Genesis Solar Energy Project - Docket Number 09-AFC-8

SUBJECT: Revisions to Jurisdictional Waters for the Genesis Solar Energy Project

Revisions to Jurisdictional Waters
Genesis Solar Energy Project
March 13, 2010

WATERS EVALUATION
INDEX MAP

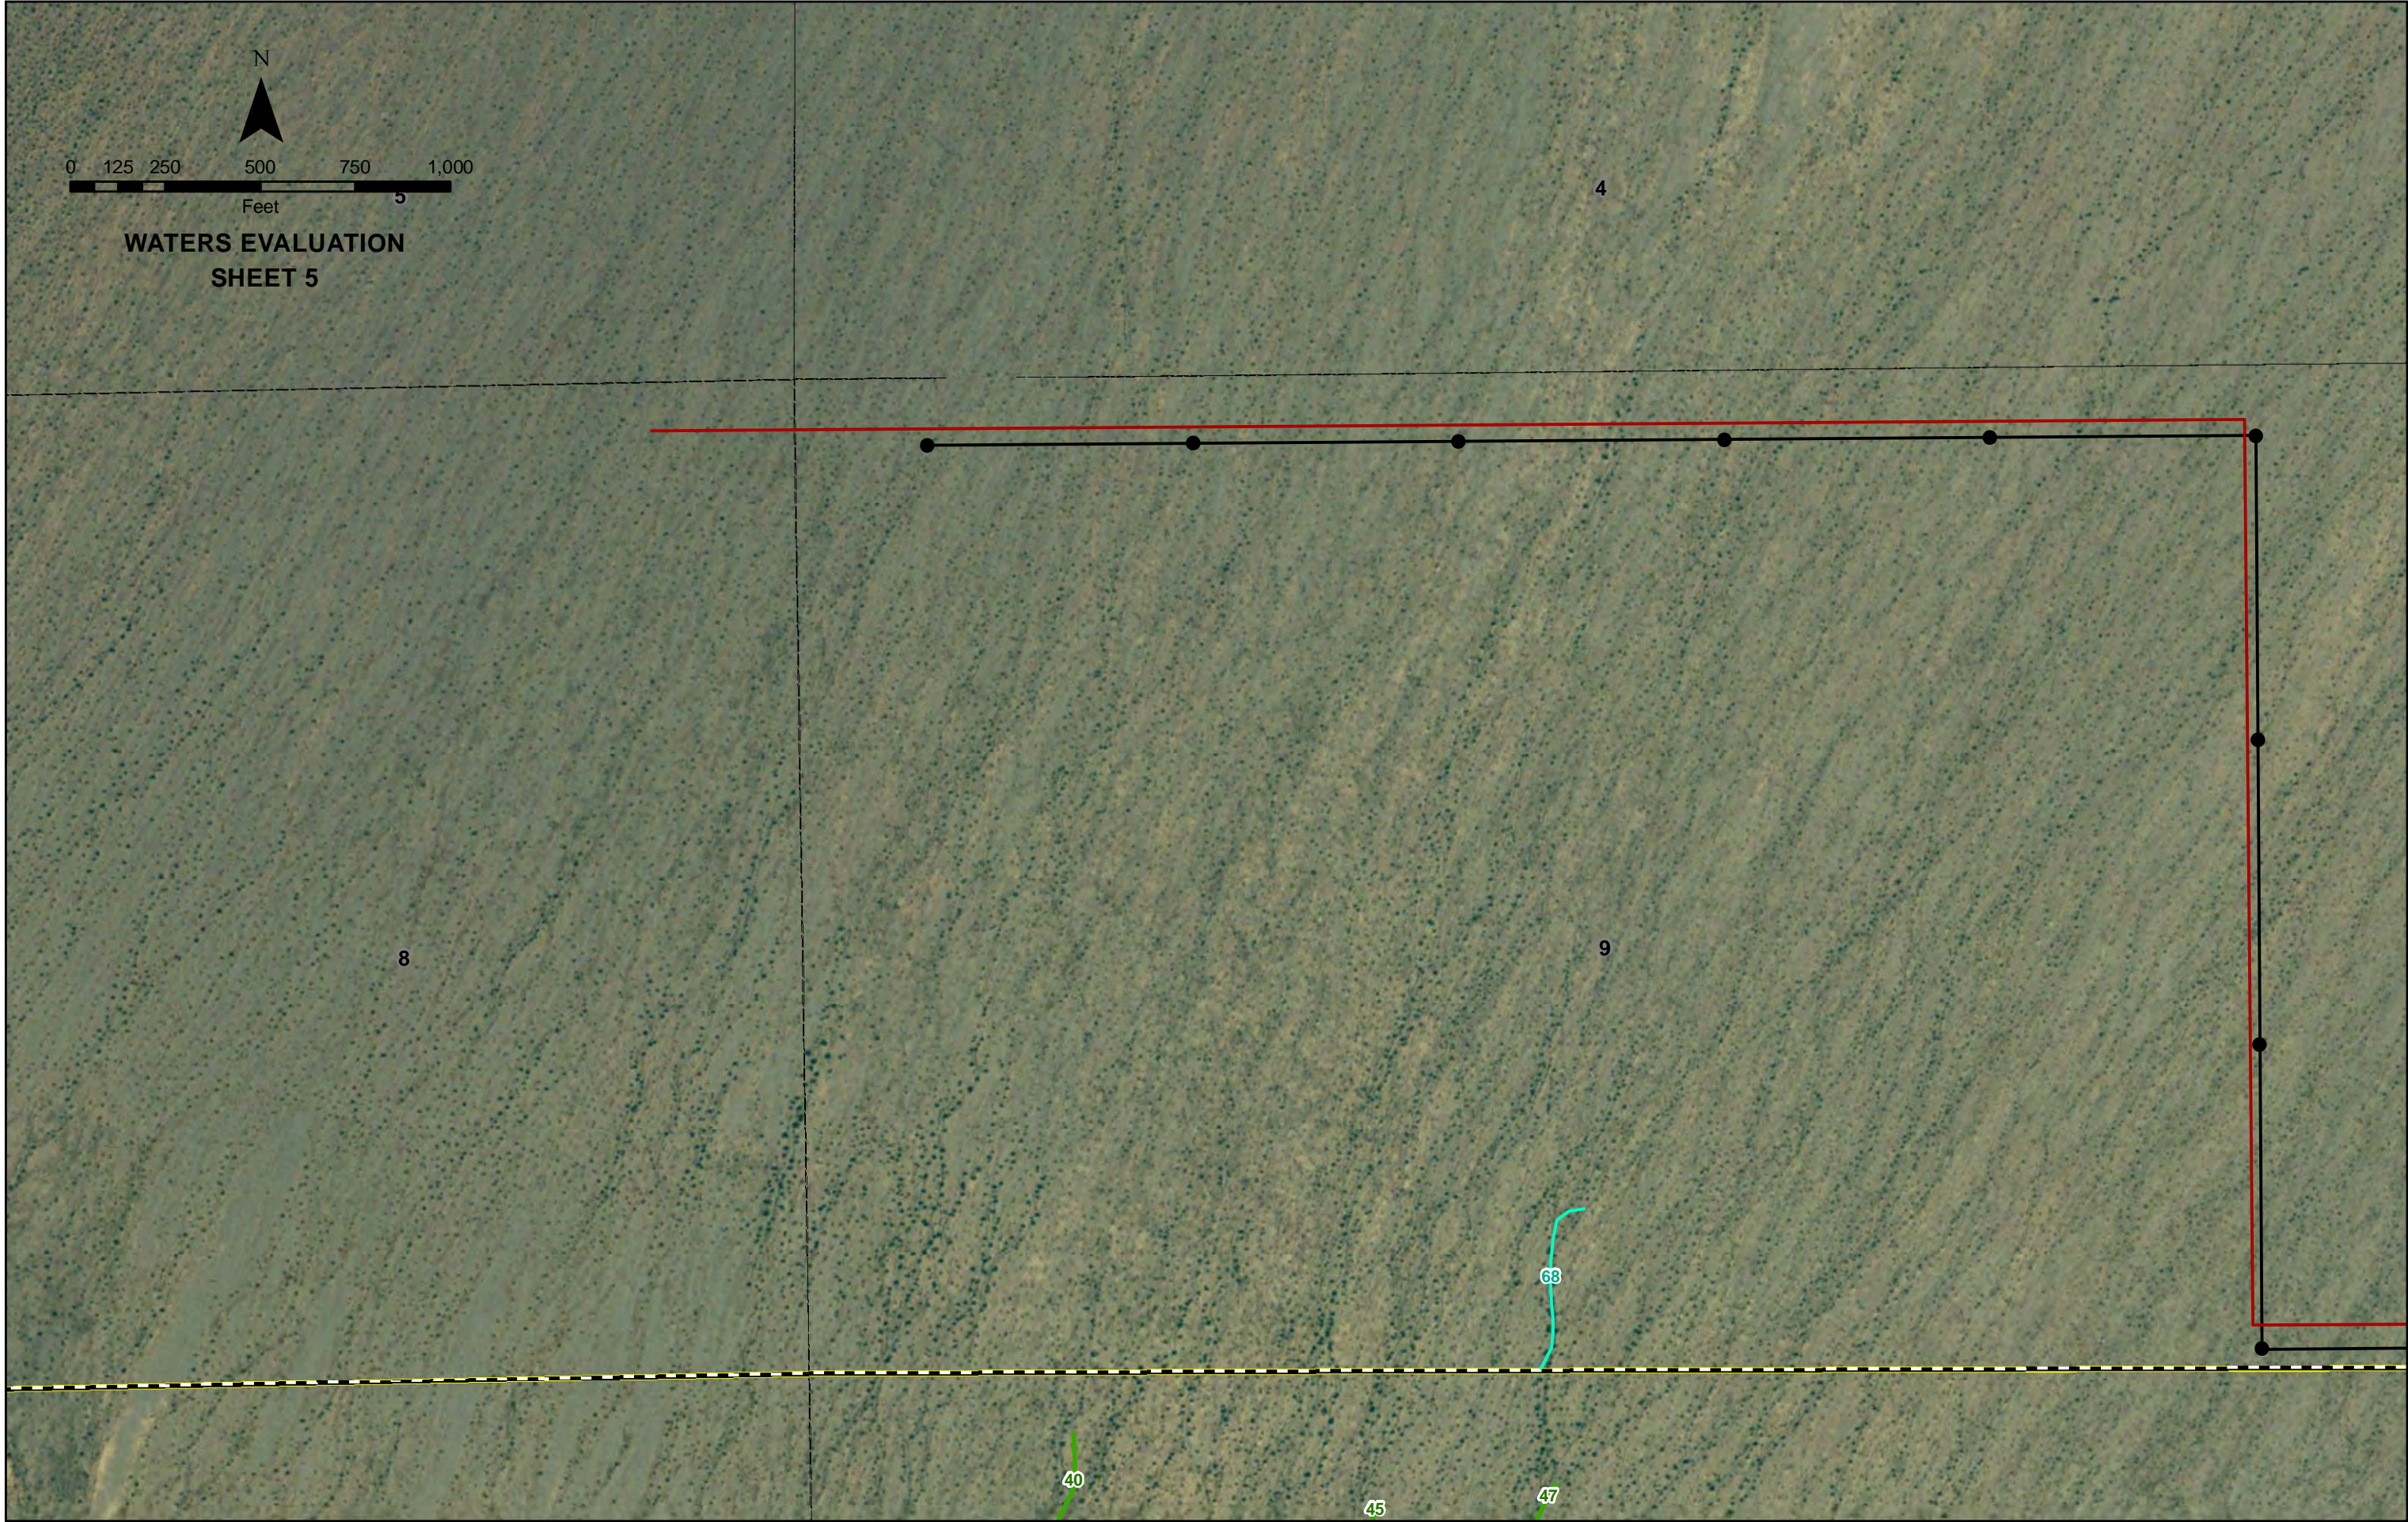
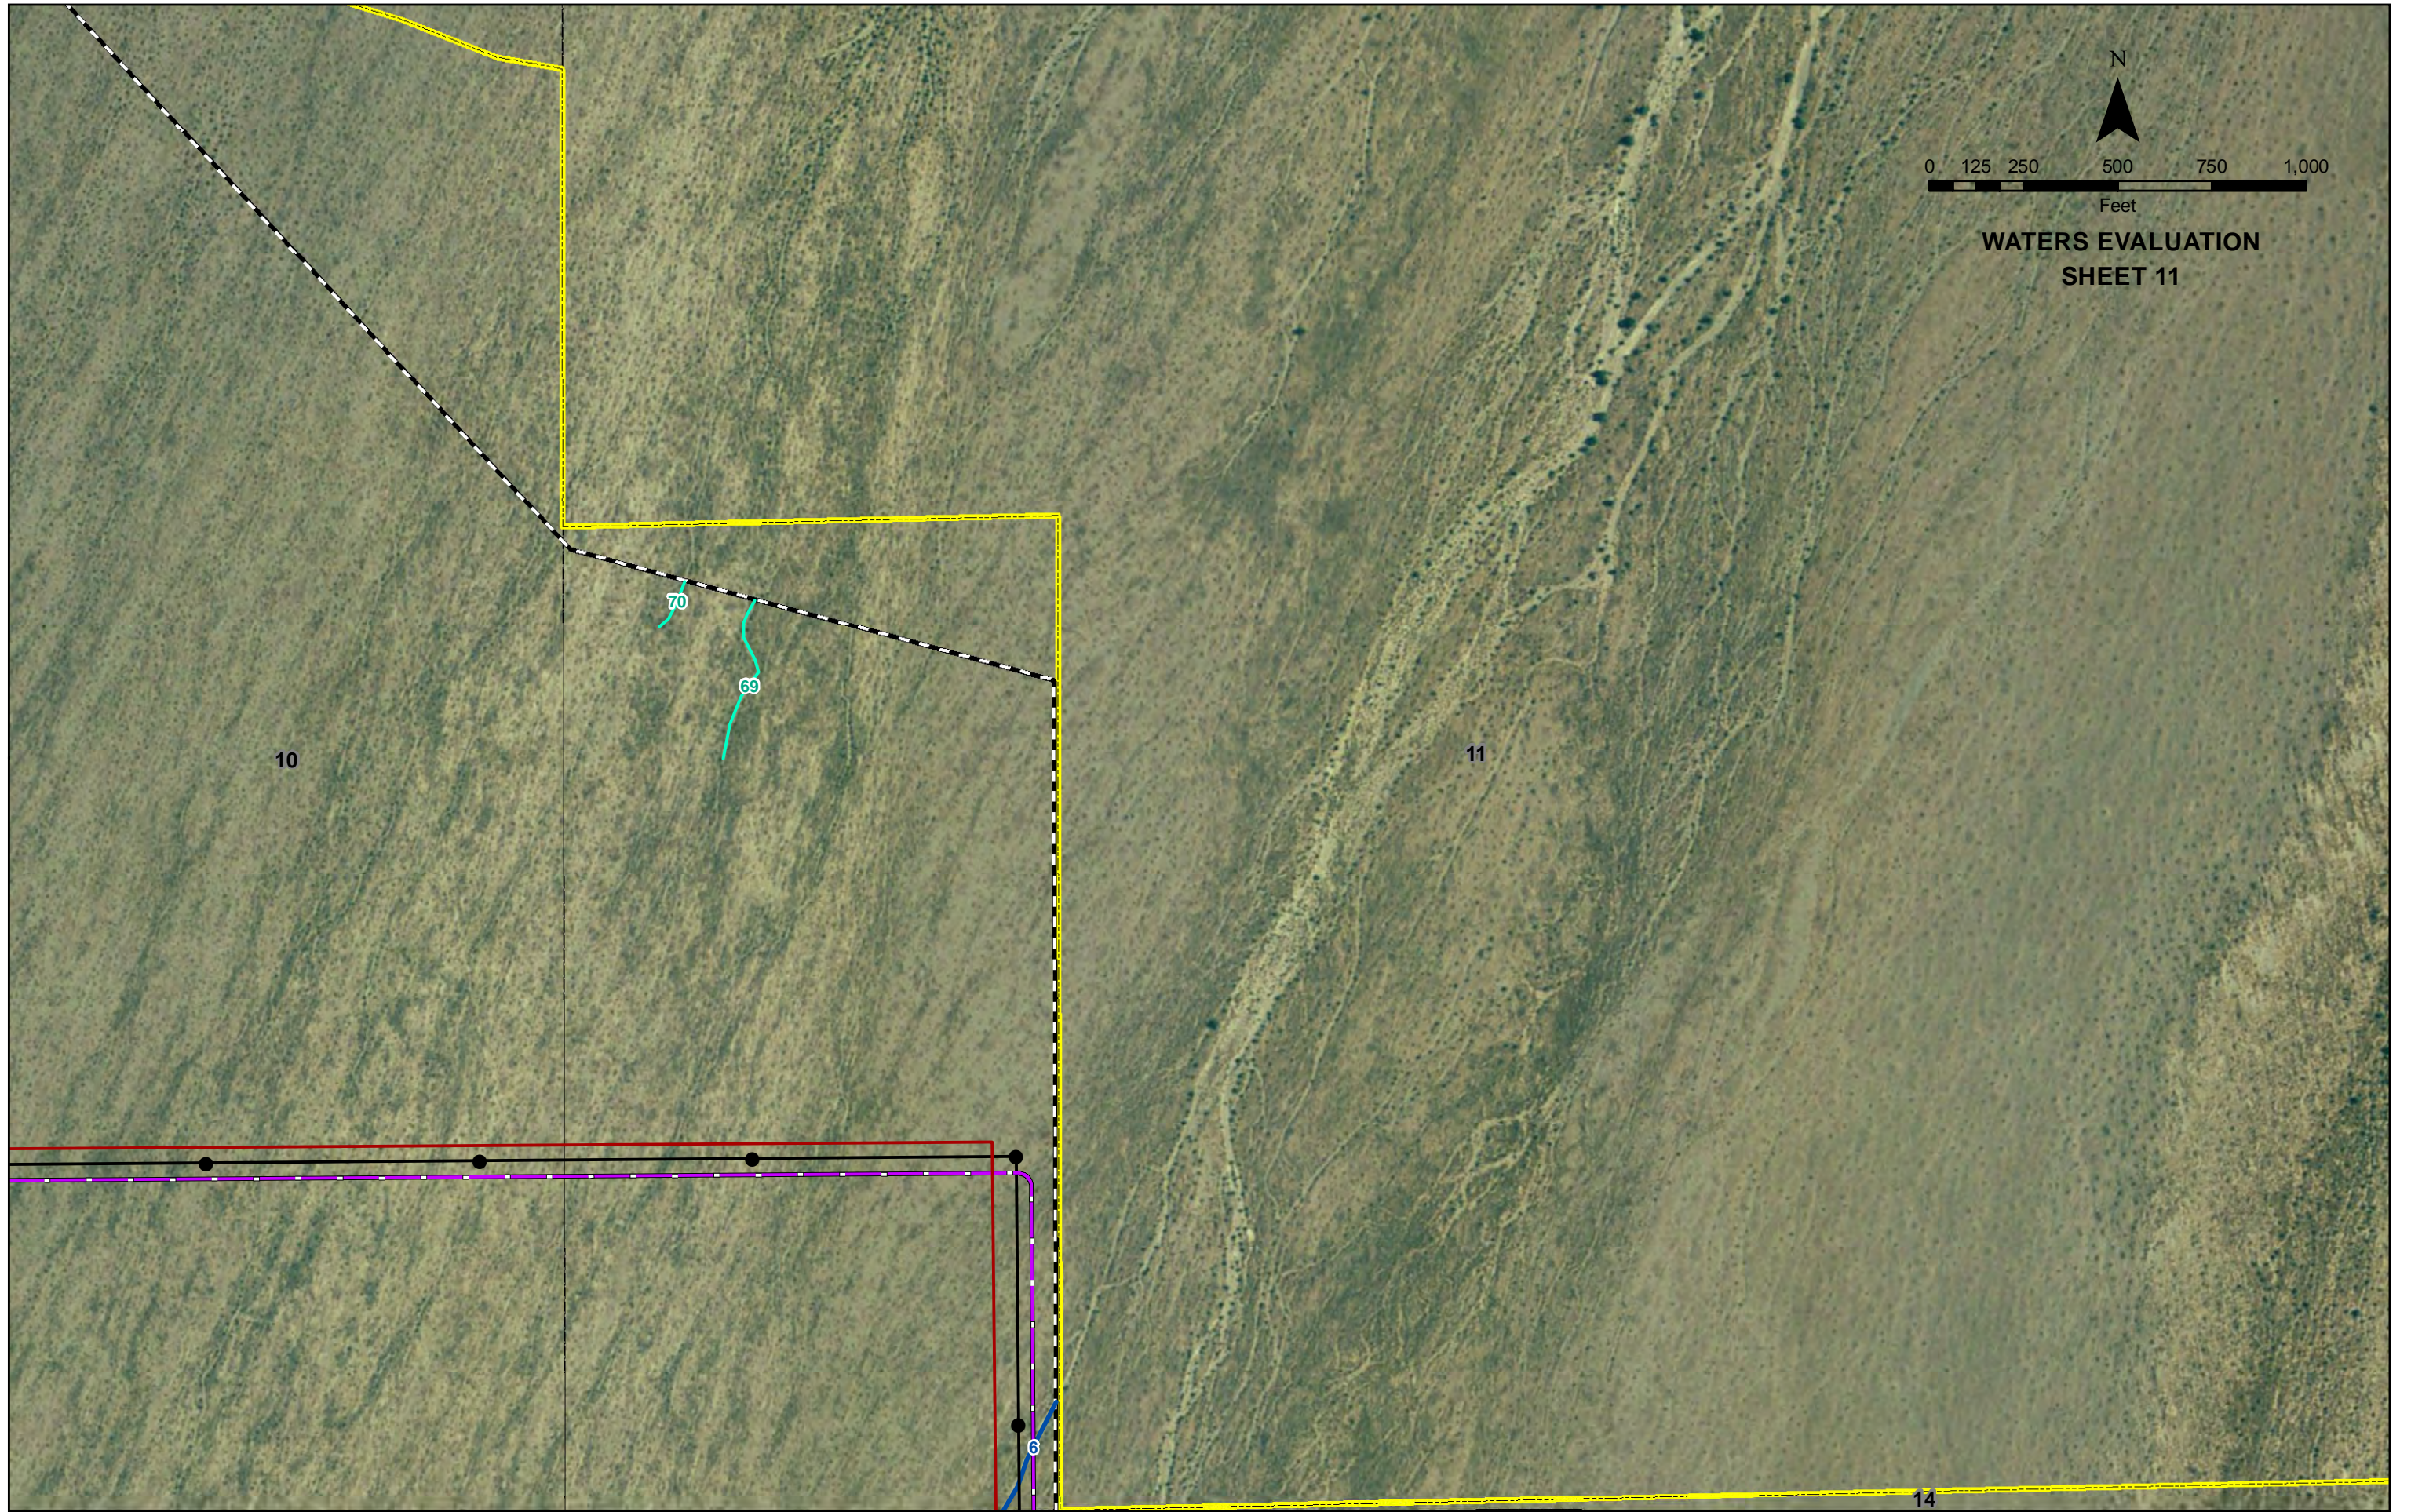
On February 17, 2010, you attended a field visit to the Genesis Solar Energy Project, primarily to evaluate tortoise habitat. During that site visit, you walked a portion of the Plant Site (project footprint) and took the opportunity to look at any water features (e.g., drainages, washes) you encountered. You evaluated a few of the delineated drainages in the *Jurisdictional Waters and Wetlands Report* for the Genesis Solar Energy Project (submitted in January 2010) to see if you agreed with the assessment. Additionally, you took note of water features that were not included in the report, but felt met the criteria for state waters, and should thus be included in the delineation report and impact calculations.

Genesis Solar, LLC (Genesis Solar) understands that your assessment is based only on the areas that you walked and that it is not a complete verification of the delineated drainages within the Project area. However, based on your field visit, you have determined that most of the western portion of the Plant Site is flat with low channels that exhibit a sheet flow pattern, as well as short narrow channels that come in and out of existence.

Per your request, Genesis Solar has revised the appropriate table and figures to depict the drainages you delineated in the field on February 17, 2010. Specifically, updates have been made to Appendix C. *Washes and Microphyllous Vegetation Directly Impacted by Project Facilities* and Map Sheets 2, 4, 5, 11, and 12 of the *Jurisdictional Waters and Wetlands Report* submitted in January 2010. The added drainages result in an additional 7.80 acres of permanent impact, 0.00 acres of temporary impact, 2 additional impacted trees (ironwood trees), and 0.00 acres of microphyll vegetation areas. The area permanently impacted by the Project is now 72.64 acres.
